TECHNICAL EVALUATION REPORT

EVALUATION OF SPENT FUEL RACKS STRUCTURAL ANALYSIS

PHILADELPHIA ELECTRIC COMPANY

PEACH BOTTOM UNITS 2 AND 3

Figure 1. Spent Fuel Storage Rack Arrangement Unit 2

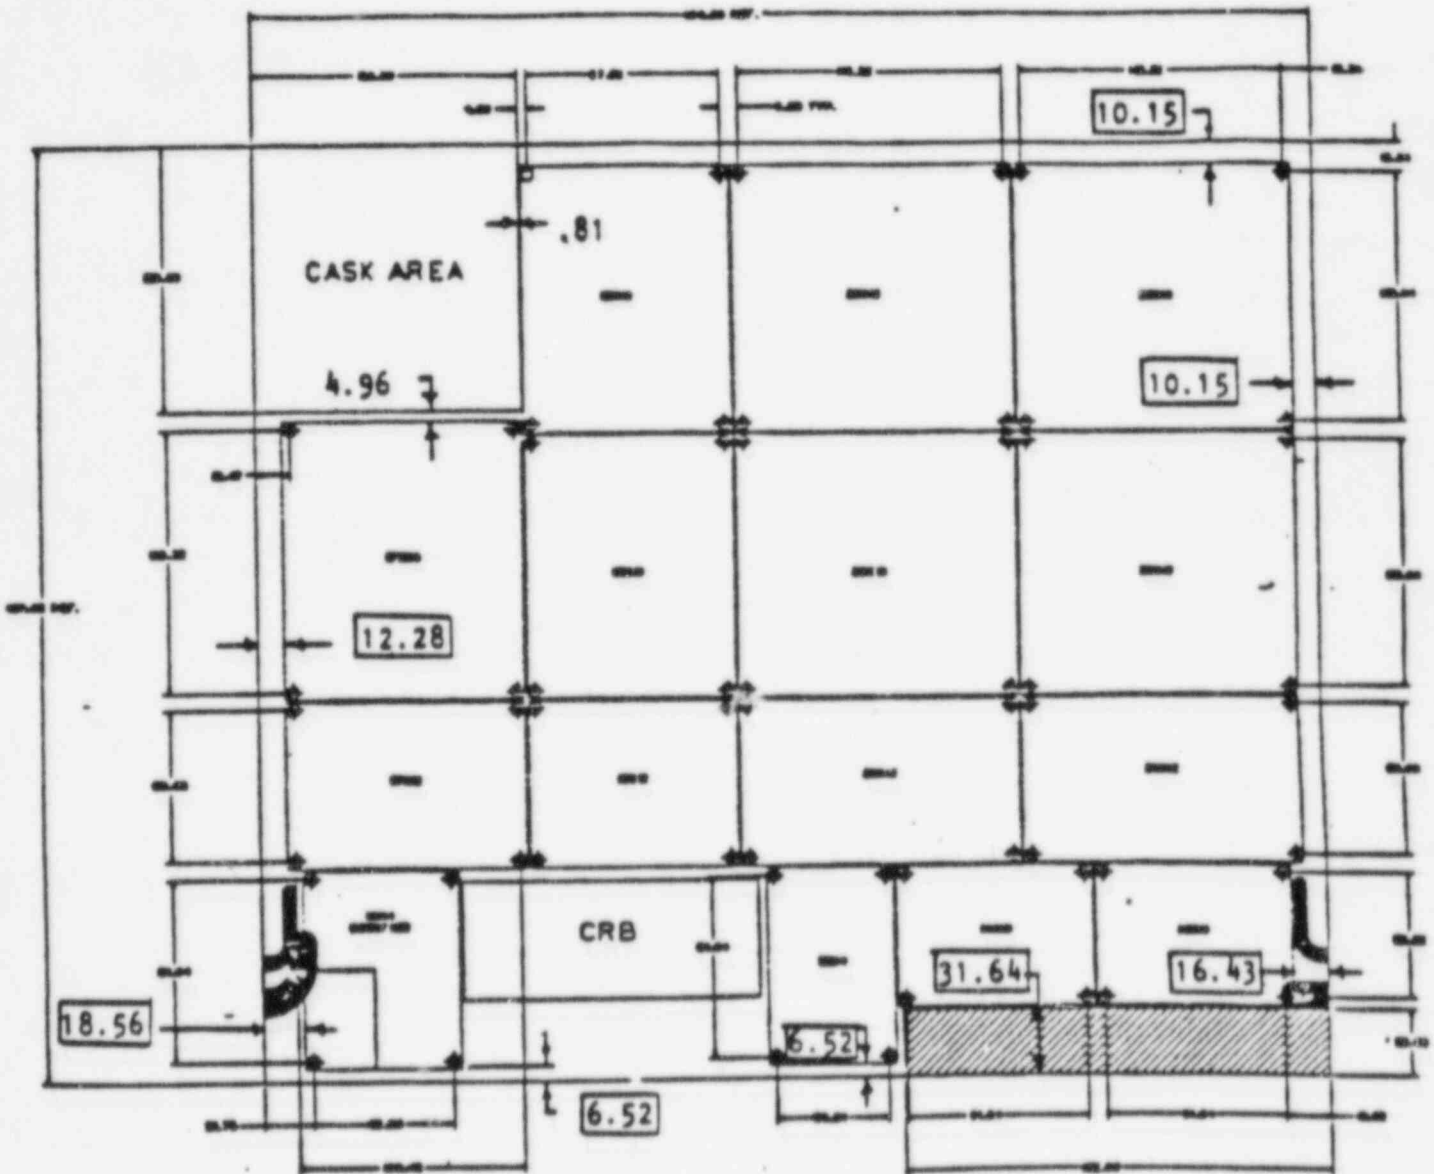
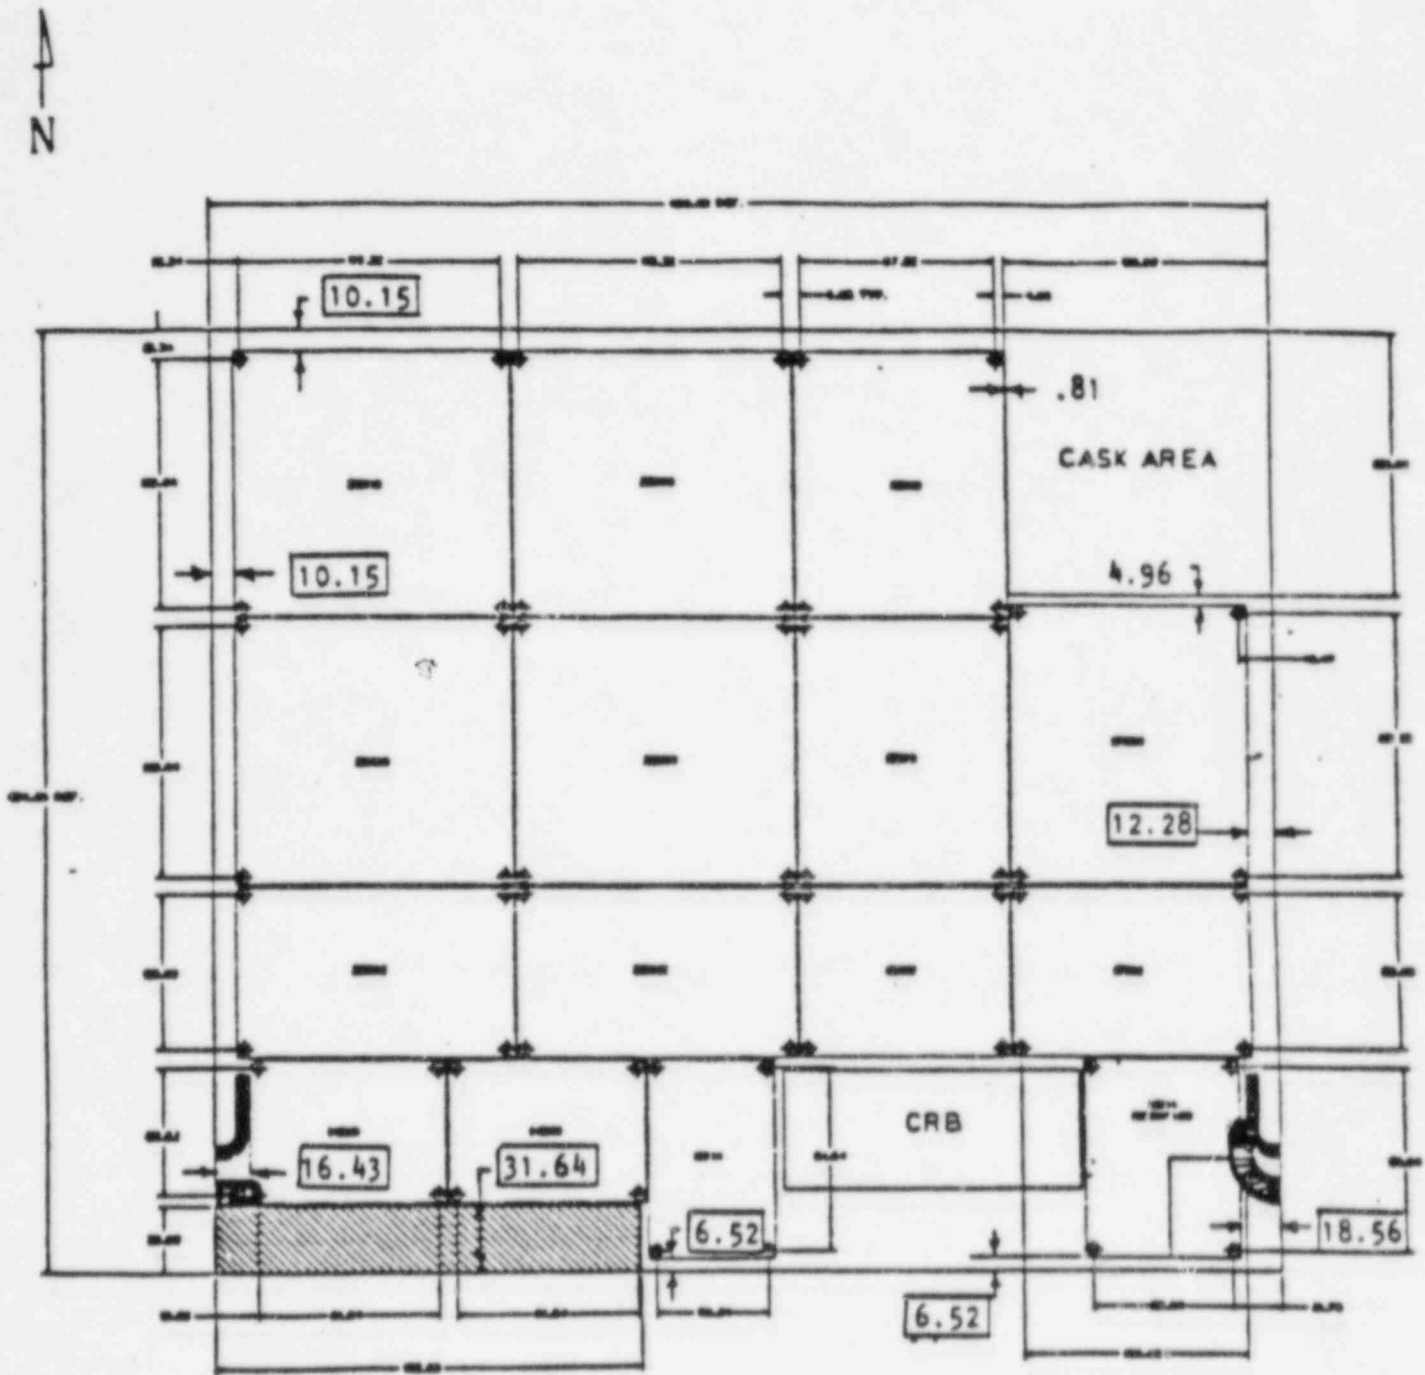
While the use of the square root of the sum of the squares is a reasonable approach to combining out-of-phase displacements of adjacent rack modules for comparison to the available clearance space, the worst possible case is that of direct summation of the rack's displacement. This worst case would represent the point in time when the responses are 180 degrees out of phase. Thus, using the Licensee's displacement data as shown in Table 2, it can be seen that even the direct sum of two total displacements is less than the clearance space of 1.68 inches. Note that the clearance space between the rack modules and pool structure, as shown by the boxed dimensions in Figures 1 and 2, is much larger.

The evaluation of the Licensee's computed maximum displacements and their comparison with the installed clearance space indicated that they are acceptable, and that rack module impacts with other rack modules and the pool structure is unlikely.

Figure 3. Three-Dimensional Nonlinear Seismic Model

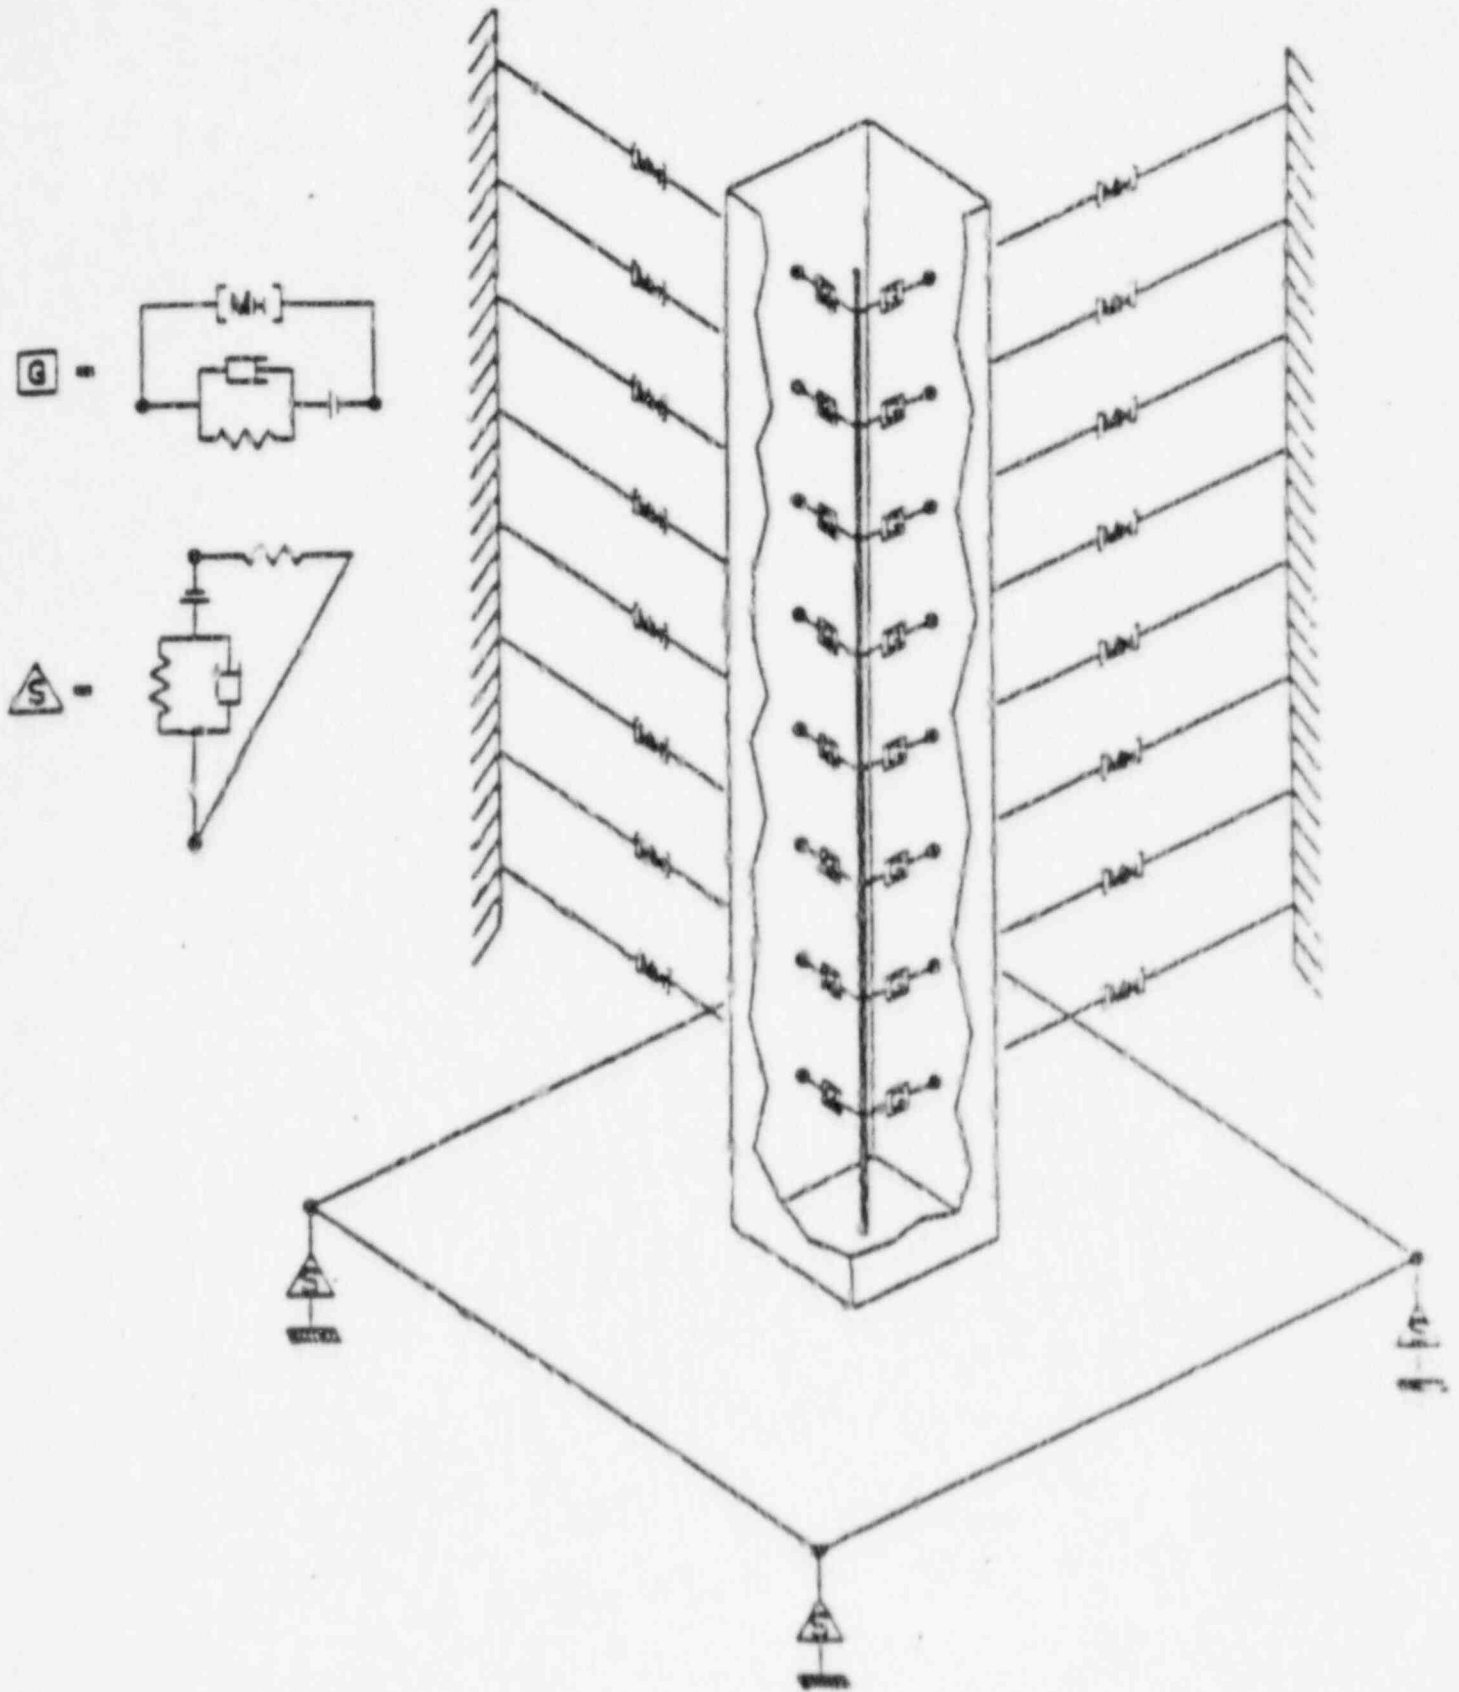
The effective structural properties of the single cell model shown in Figure 3 were modeled by three-dimensional beam elements and were derived from linear three-dimensional analysis of the fuel rack to which the hydrodynamic mass of the water was added. The fuel assembly, modeled by beam elements and represented in Figure 3 by the heavy vertical line, was connected to the cell walls through springs, dampers, gap elements, and hydrodynamic mass of the water in the cell. This model enabled the simulation of fuel assembly motion in the clearance space between the fuel assembly and the rack cell walls, as well as impact with the cell walls.

The Licensee's modeling of the rack modules and use of fuel assembly impact damping is acceptable.

Figure 4. Structural Model (Quarter Rack)

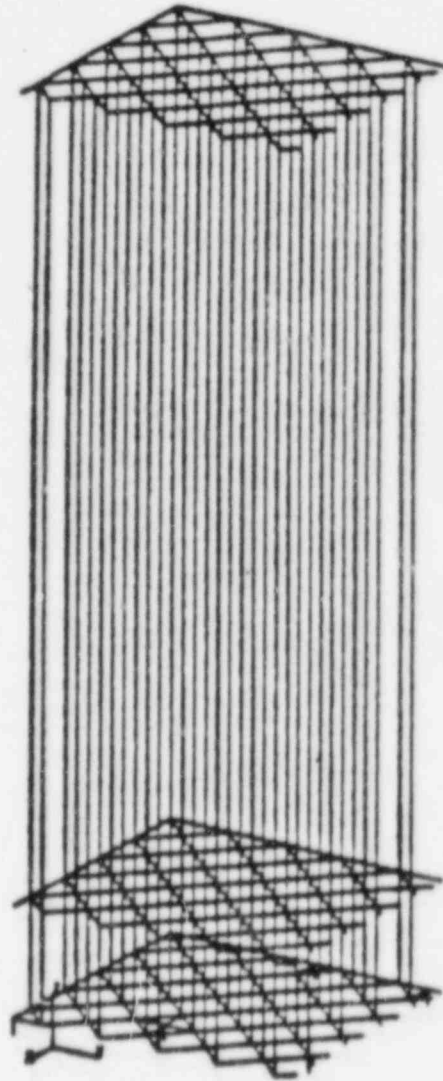
"The structural model, shown in [Figure 4], is a quarter section representation of the rack assembly consisting of beam elements interconnected at a finite number of nodal points and general mass matrix elements. The

The results of the seismic displacement analyses were searched throughout the full analysis time to obtain the maximum response forces. These maximum values were then adjusted by peaking factors from the structural model to account for stress gradients through the rack module [1].

Evaluation of the rack module stresses indicated that the analysis, level of stresses, and acceptability criteria are satisfactory.

Figure 5. Section of Three-Dimensional Nonlinear Seismic Model

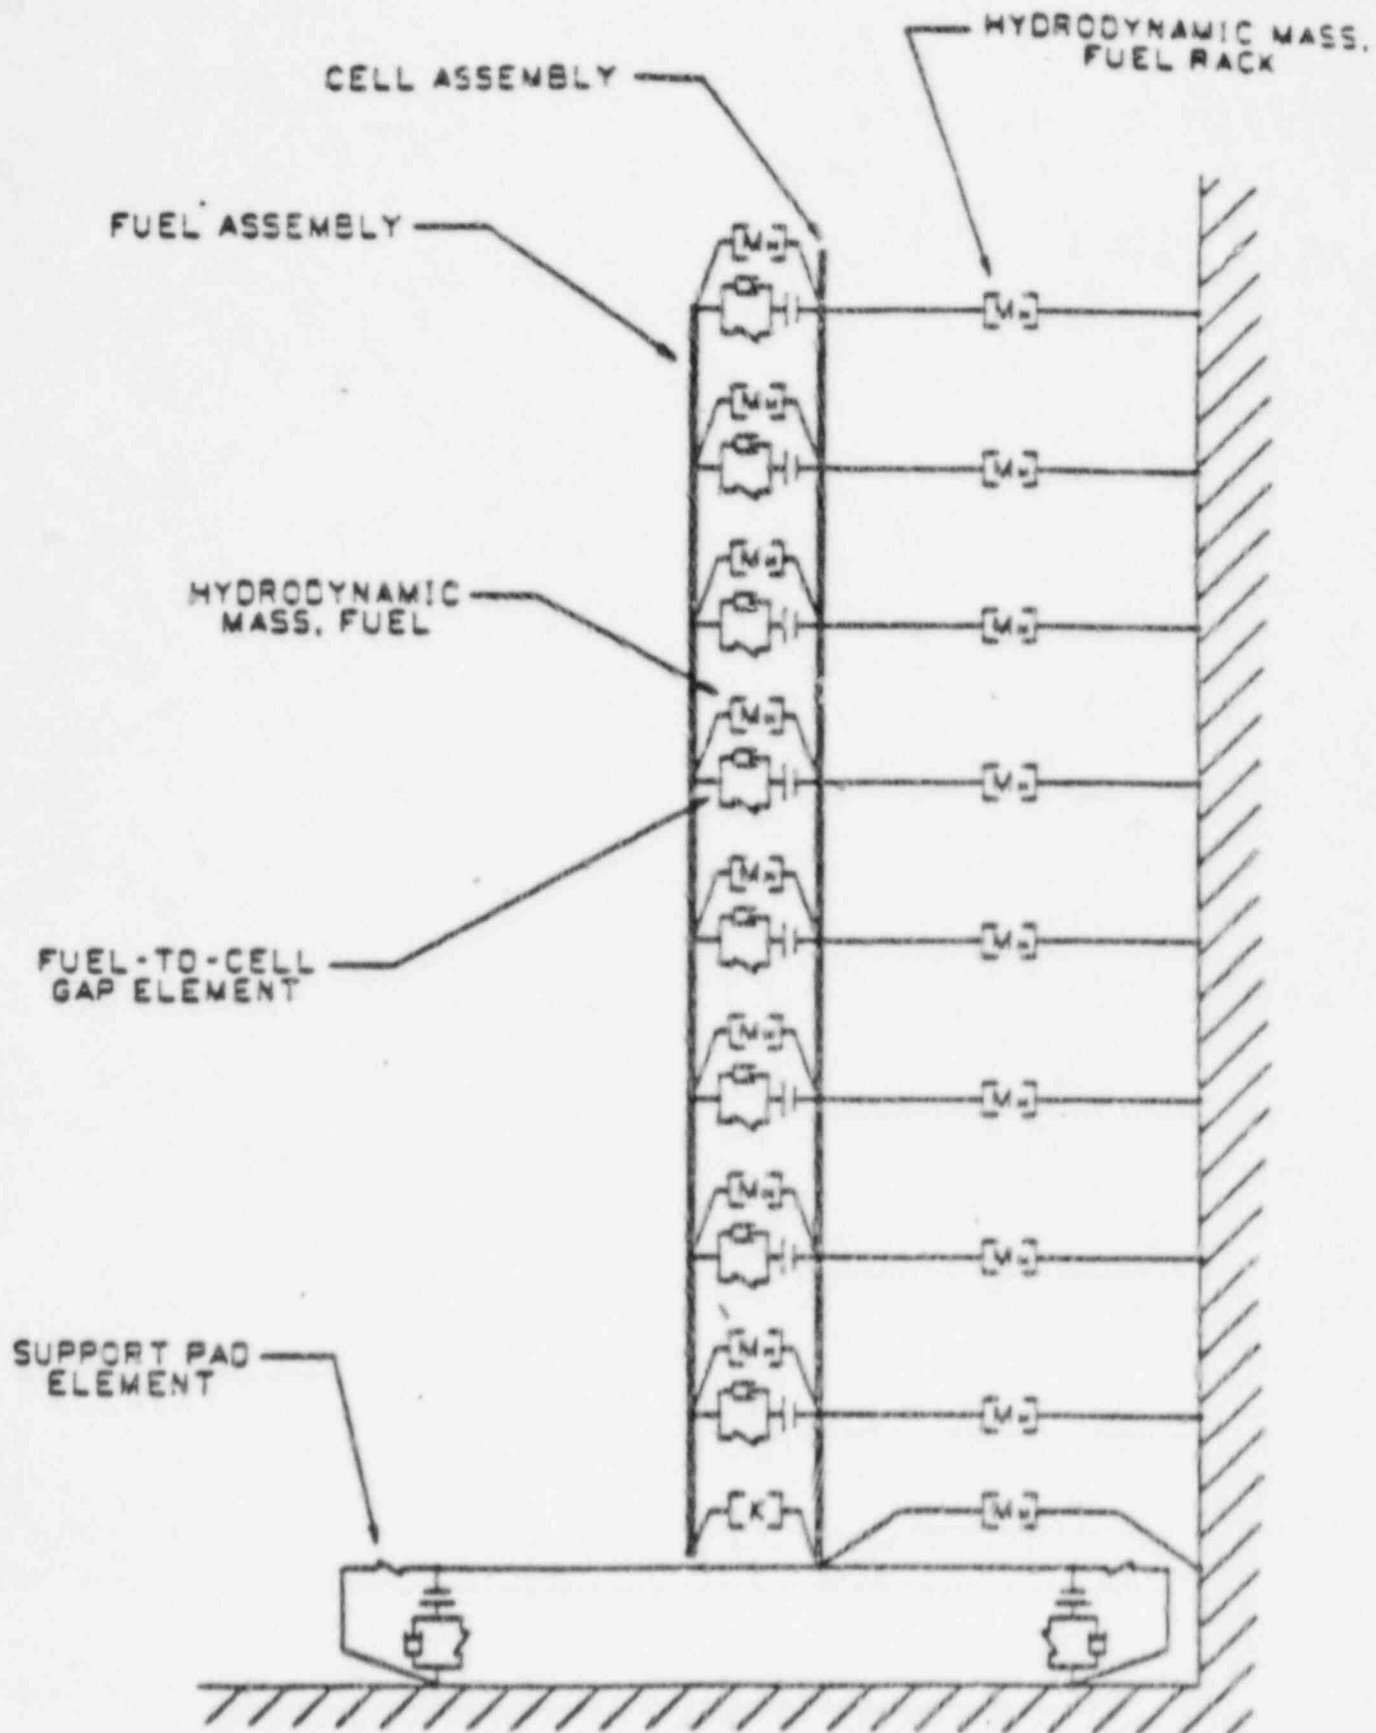
Thus, the limitations of Fritz's [5] modeling technique for hydrodynamic coupling of rack modules adjacent to other rack modules or a pool wall indicate that the Licensee's fuel rack dynamic model should be considered conservative only for dynamic displacements that are small relative to the available displacement clearance.
